SOAH DOCKET NO. 582-22-0844
TCEQ DOCKET NO. 2021-1000-MSW

IN THE MATTER OF THE APPLICATION BY DIAMOND BACK RECYCLING AND SANITARY LANDFILL, LP FOR NEW MSW PERMIT NO. 2404	**§**	**BEFORE THE STATE OFFICE OF ADMINISTRATIVE HEARINGS**

PROTESTANTS KNOX REAL PROPERTY DEVELOPMENT, LLC AND JASON HARRINGTON'S EXCEPTIONS TO THE SUPPLEMENTAL PROPOSAL FOR DECISION ON REMAND

July 6, 2023

Figure 1 – Application Figure III.C1.1 with Notations[14]

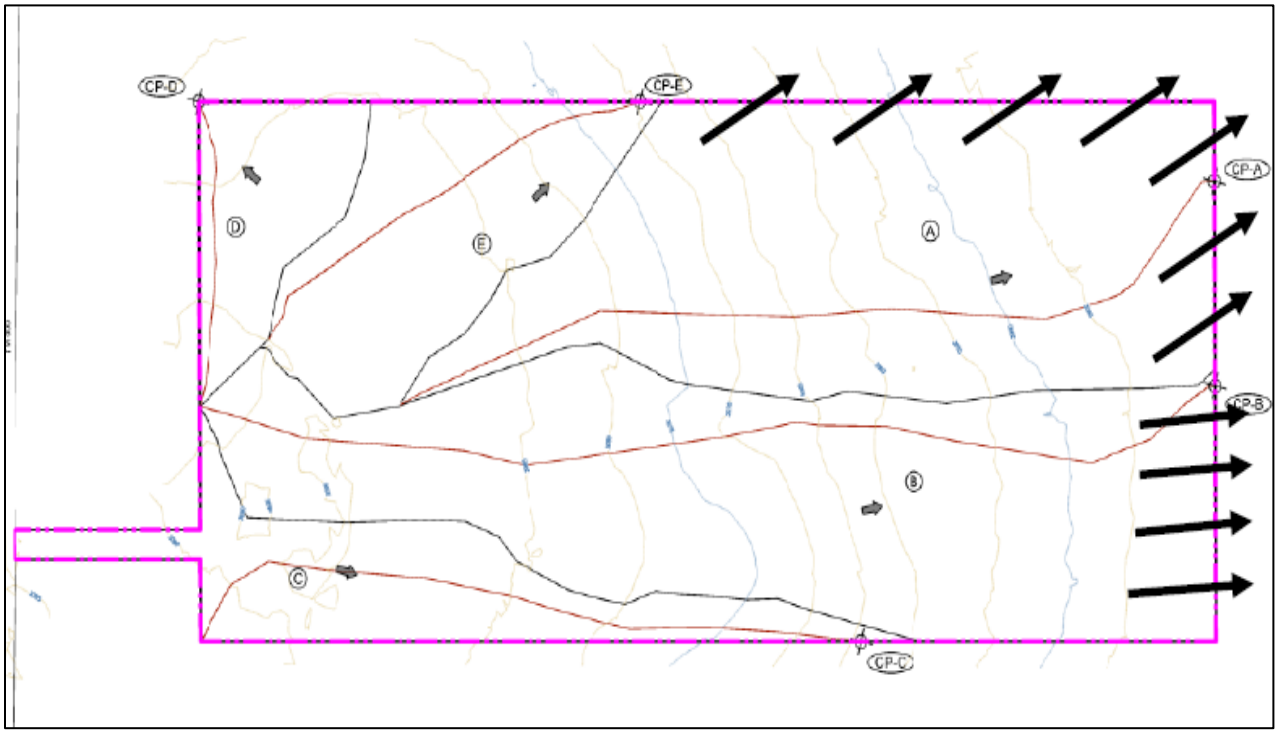
[14] Ex. Knox-202. Note that there is some dispute about whether the surface water exiting the boundary of drainage area A flows to the north and the east or only to the east. For purposes of calculating peak flow rates using the Rational Method, however, the surface water flow direction is not relevant. Tr. V.2, p.70.
[15] Ex. Knox-203.

along the permit boundary.[26] So, for instance, even though Diamond Back has represented that drainage area A, under existing conditions, has a peak flow rate of 65 cfs at CP-A (or comparison point A), water does not discharge at that specific discharge point at a rate of 65 cfs; there is no single point along the drainage area A boundary where water leaves the site at a peak discharge rate of 65 cfs. And even though Diamond Back has represented that drainage area B, under existing conditions, has a peak flow rate of 54 cfs at CP-B (or comparison point B), water does not discharge at that specific discharge point at a rate of 54 cfs; there is no point along the drainage area B boundary where water leaves the site at a peak discharge rate of 54 cfs.[27]

In fact, Mr. Stiggins, Diamond Back's engineer of record, testified that he could not say what the peak flow rate is for water discharging at CP-A under existing conditions—at least not based on his use of the Rational Method equation.[28] Nor could he say what the peak flow rate is for water discharging at CP-B under existing conditions, based on his use of the Rational Method. Thus, there is no dispute that the surface water drainage report does not accurately reflect the peak flow rates for existing conditions occurring at comparison points A and B.

Diamond Back takes exception to the surface water flow directions for drainage area A as reflected in Knox's Exhibit 202, but Diamond Back's engineer of record (Stiggins)

admitted that the flow directions are irrelevant to his calculated peak flow rates. So, the dispute regarding flow direction for drainage area A is irrelevant to the issue presented here: whether Diamond Back has accurately represented peak flow rates for existing conditions occurring at the site.
